# Submissions Report

WELLINGTON NORTH SOLAR PLANT

Wellington North Solar Plant

Project Number: 17-382

Figure 3-1 Updated Proposal location.

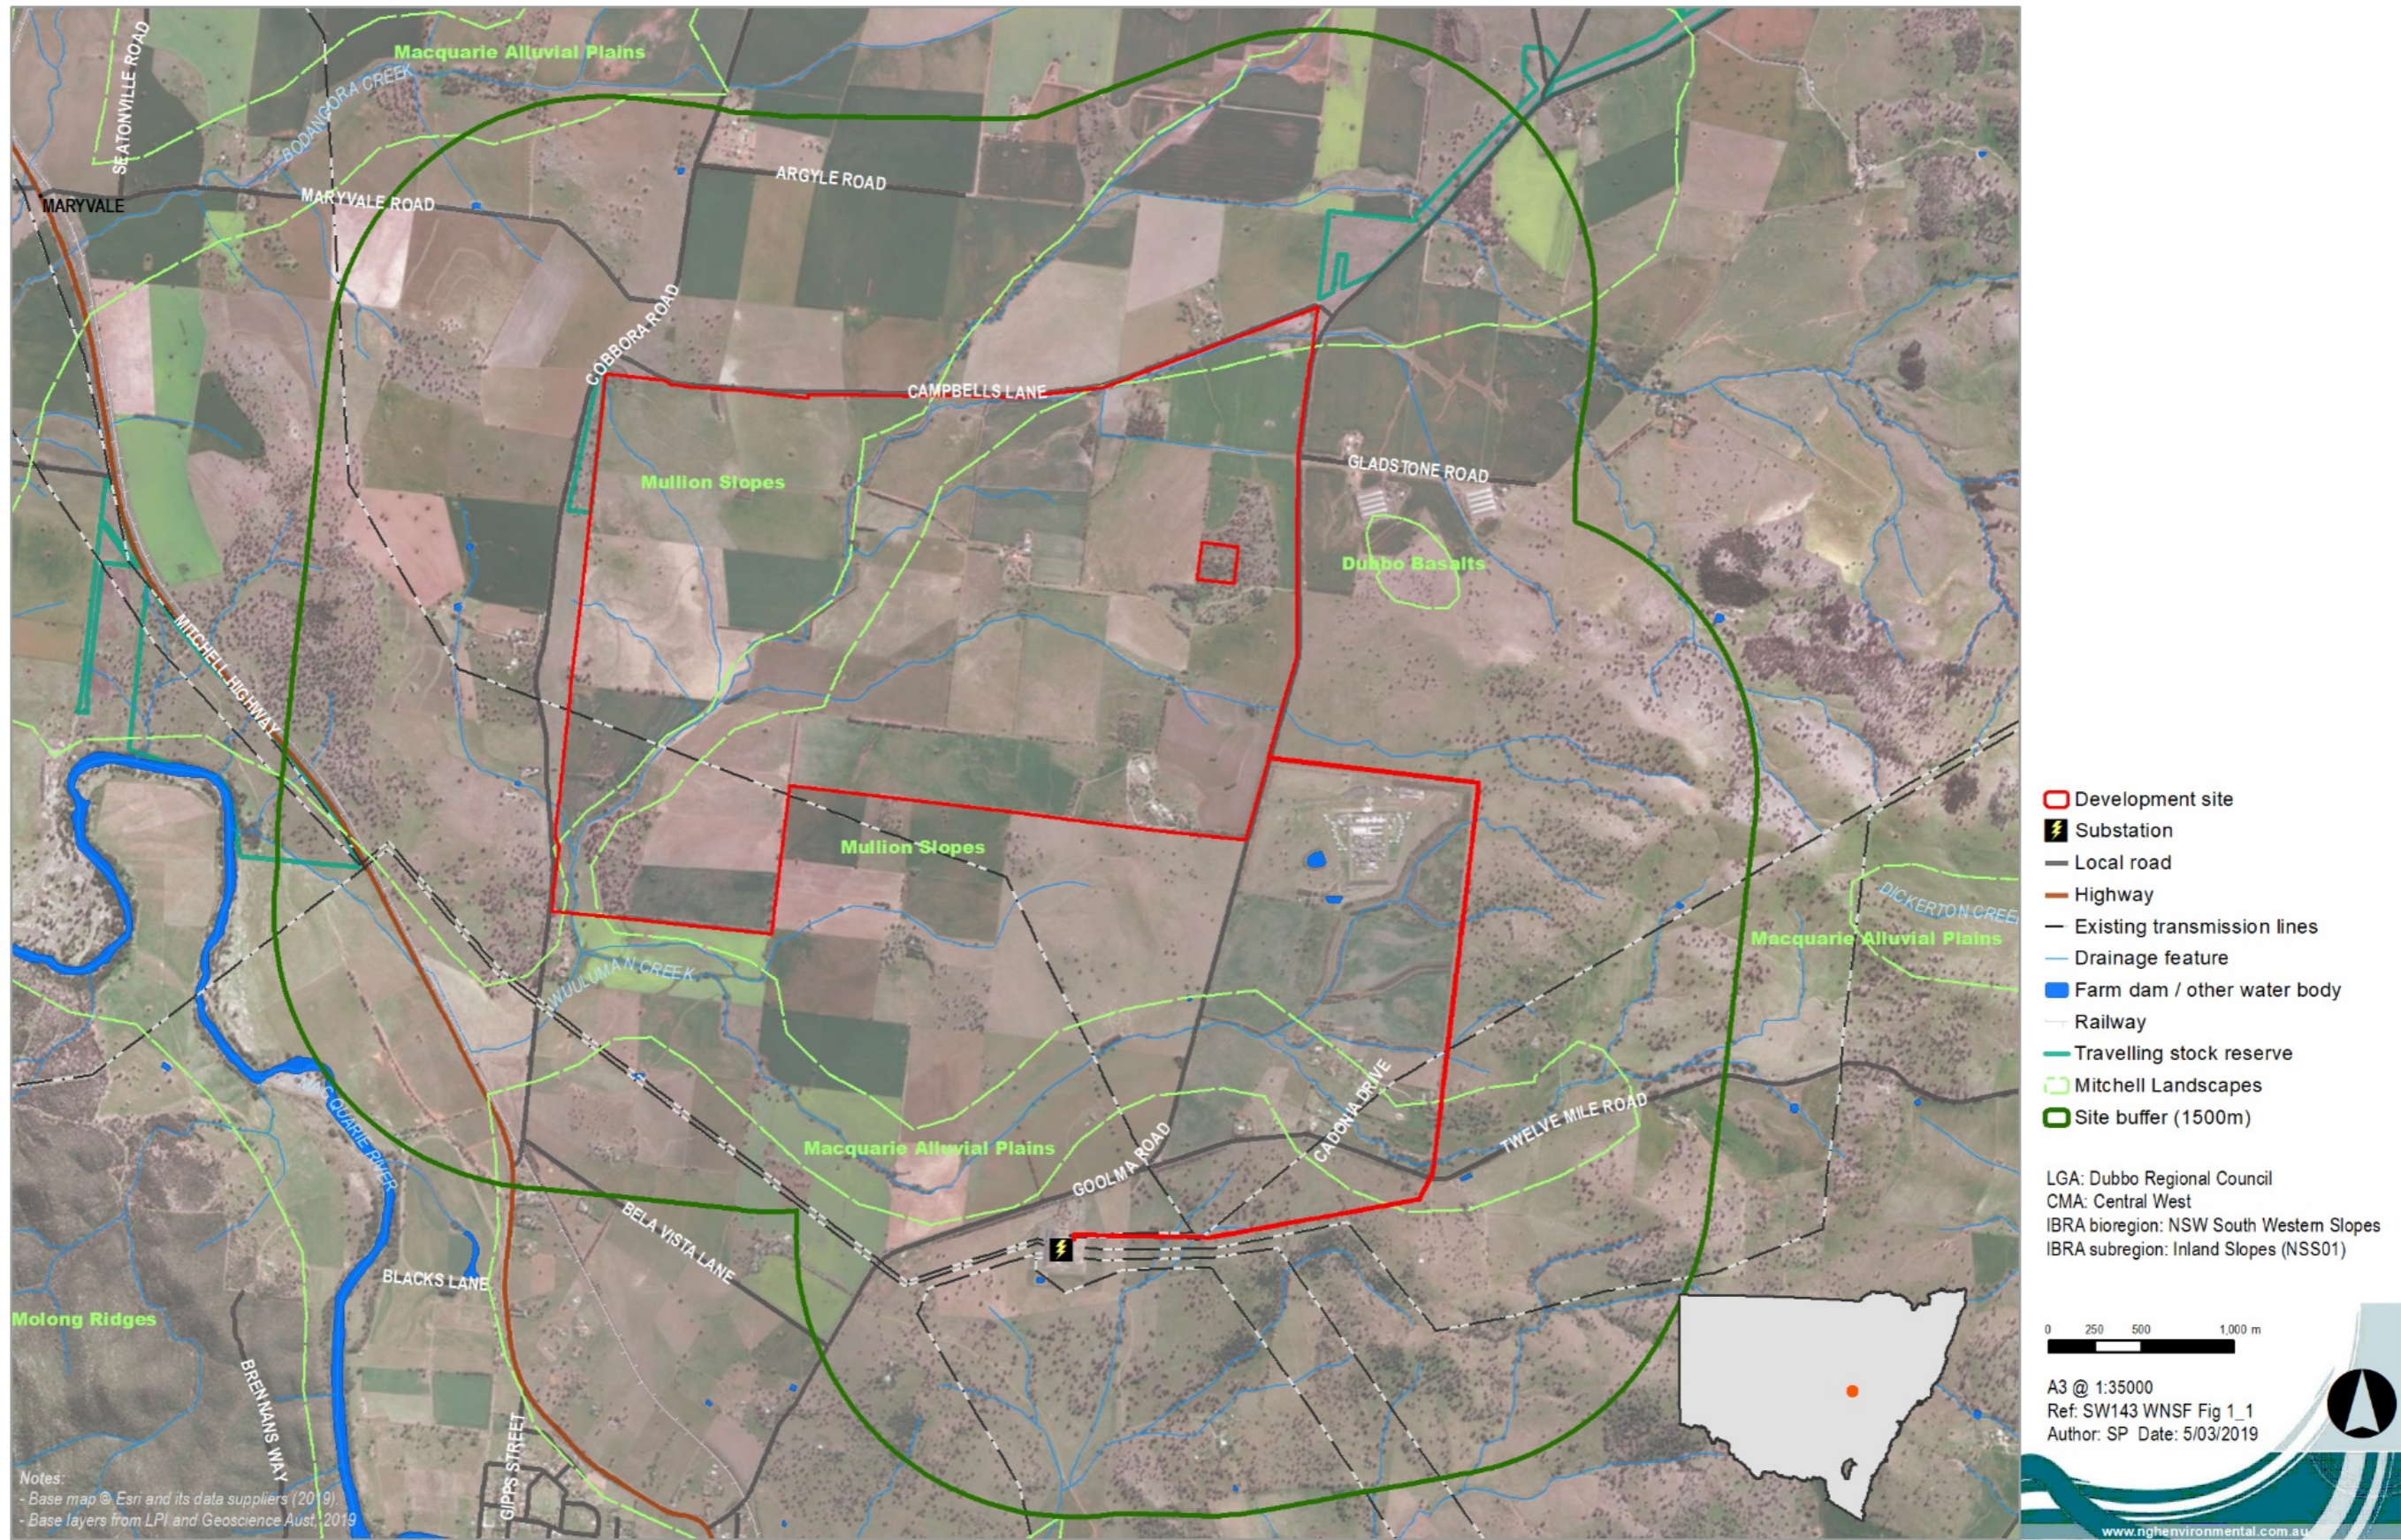
The Wellington North Solar Plant proposal remains generally as detailed in Section 4 of the EIS (NGH Environmental 2018). However, two changes have been made and are detailed in this section.

These changes can be seen in the updated proposal layout and constraints map provided in Figure 3-1 and Figure 3-2.

Figure 3-2 Updated constraints mapping reflecting the proposal changes, showing the approved Wellington Solar Farm (First Solar) to the south of the site.

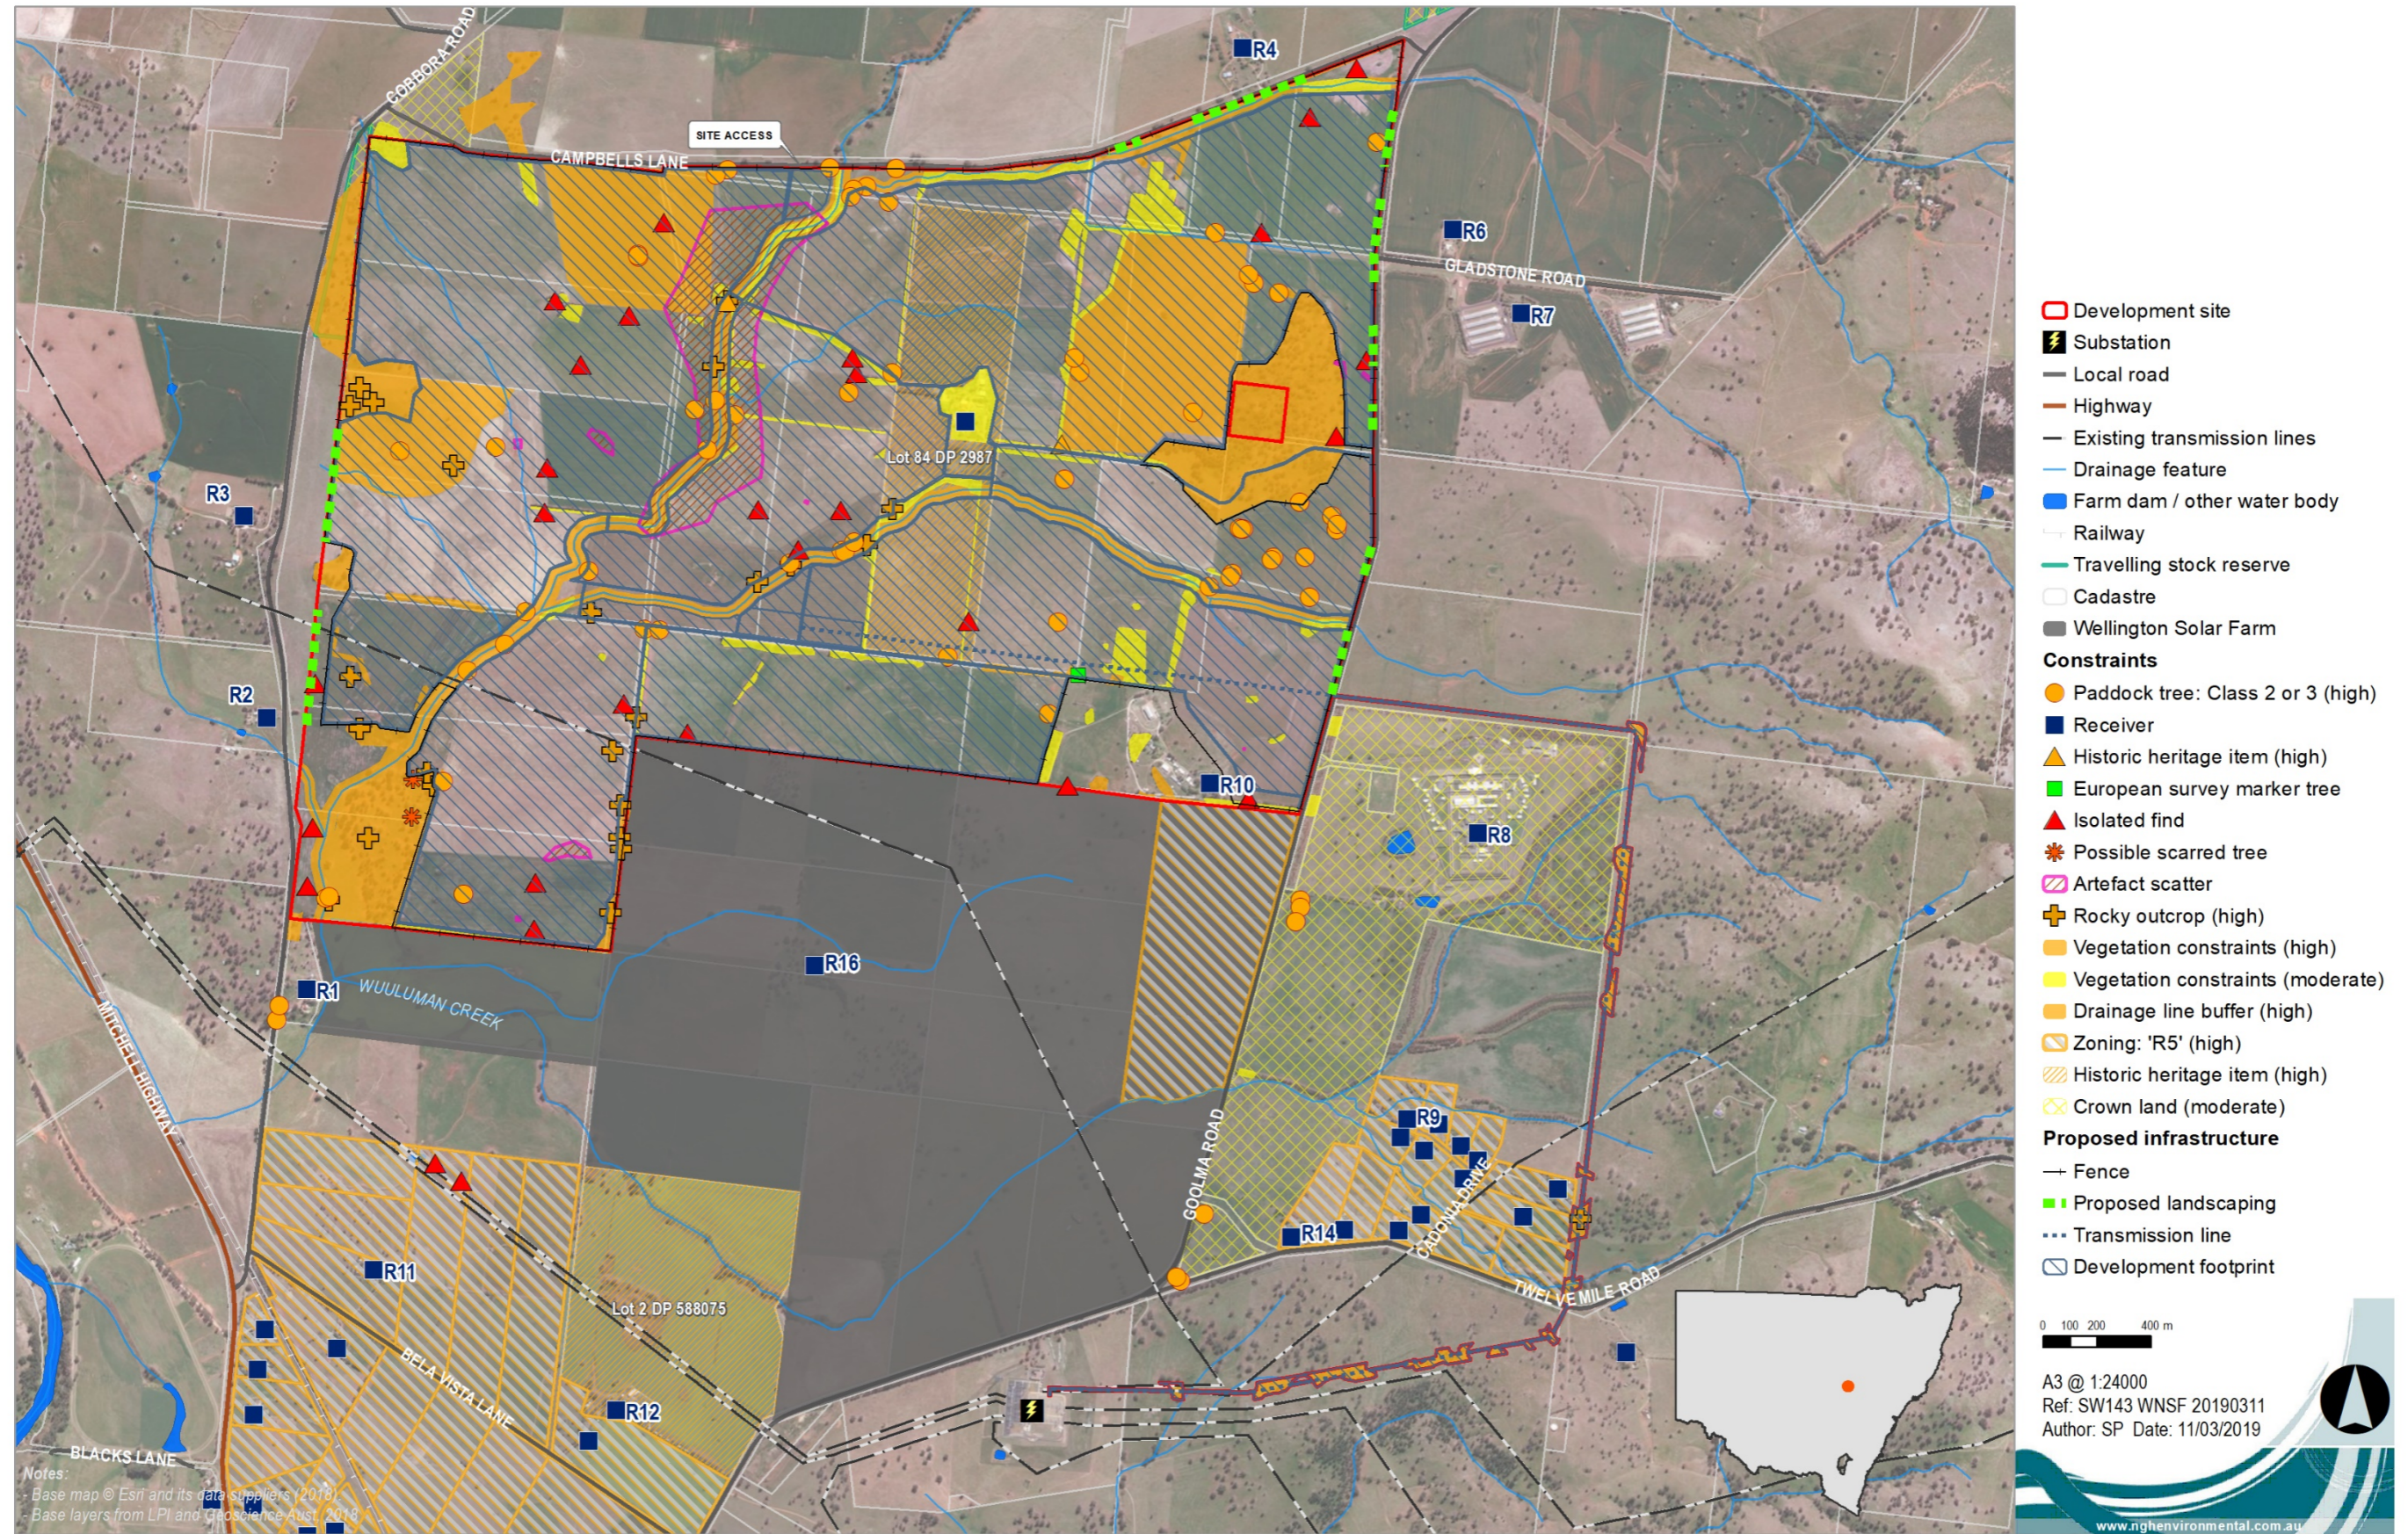
Issue	Detail of issue	Proponent response
		<p>The location of the proposed screen planting can be seen in Figure 3-2 and has been developed specifically to augment existing vegetation screening at specific viewpoints. The additional planting requested, rather than softening the impact of views of infrastructure, is considered likely to create an unnatural hedge effect, not in keeping with the existing vegetation formations. Blocking views entirely of the solar farm is not proposed and not considered warranted.</p> <p><b>No changes to the proposal or mitigation measures are proposed in response to this issue.</b></p>
<p><b>Landscaping</b></p>	<p>Dubbo Regional Council requests a condition be included on the consent that prior to issue of a Construction Certificate a detailed Landscape Plan be submitted for approval which includes details of:</p> <ul style="list-style-type: none"> <li>• Setback of landscaping from the solar panels and property boundaries;</li> <li>• Evidence of how the landscaping conforms to the requirements of any bushfire Asset Protection Zone (APZ);</li> <li>• The height of plantings at the time of planting (being of advanced stock);</li> <li>• Species planted; and</li> <li>• Nature of irrigation to be used.</li> </ul> <p>It is further requested the landscaping have a minimum mature height of 3 metres utilising deep rooted, water tolerant, native plant species endemic to the Wellington local area. Dubbo Regional Council staff can be consulted on the type of species chosen. Such landscaping as a minimum should be undertaken in stages to correlate with the construction of the adjacent solar panel(s).</p>	<p>The EIS includes a Landscaping plan (refer to Figure 3-1 and Figure 3-2) and commitments for landscaping. The landscape plan and the mitigation measure below addresses councils requirements for the landscaping setbacks, planting heights, species, timing and management of the screening. Mitigation measures regarding bushfire management, which includes APZs provides evidence that they are being considered as part of the Proposal.</p> <p>The following mitigation measure has been included in the EIS regarding landscaping, to fragment / soften the view of infrastructure:</p> <ul style="list-style-type: none"> <li>• <i>An intermittent band of screen planting would be located:</i> <ul style="list-style-type: none"> <li>○ <i>Between the property boundary and the solar arrays, in locations along Goolma Road and Cobbora Road where there is no existing vegetation and where the arrays are immediately adjacent to the boundary.</i></li> <li>○ <i>Along the Campbells Lane boundary to mitigate impacts on properties on the northern side of Campbells Lane (identified in Appendix H).</i></li> </ul> </li> <li>• <i>To ensure that the screen planting integrates into the existing landscape character:</i> <ul style="list-style-type: none"> <li>○ <i>Bands of planting would be a mix of locally native tree and shrub species to ensure a naturalistic effect whilst also providing habitat and movement corridors for native fauna.</i></li> <li>○ <i>Planting would not form a consistent hedge between the road and the solar farm but rather form a row of intermittent copse plantings that reflect the existing character of roadside vegetation in the area</i></li> </ul> </li> <li>• <i>Screen planting should be considered for locations surrounding buildings associated with the proposal where appropriate.</i></li> <li>• <i>Strategies to ensure the effective screening is maximised early in the project life and maintained would be implemented, for example:</i></li> </ul>
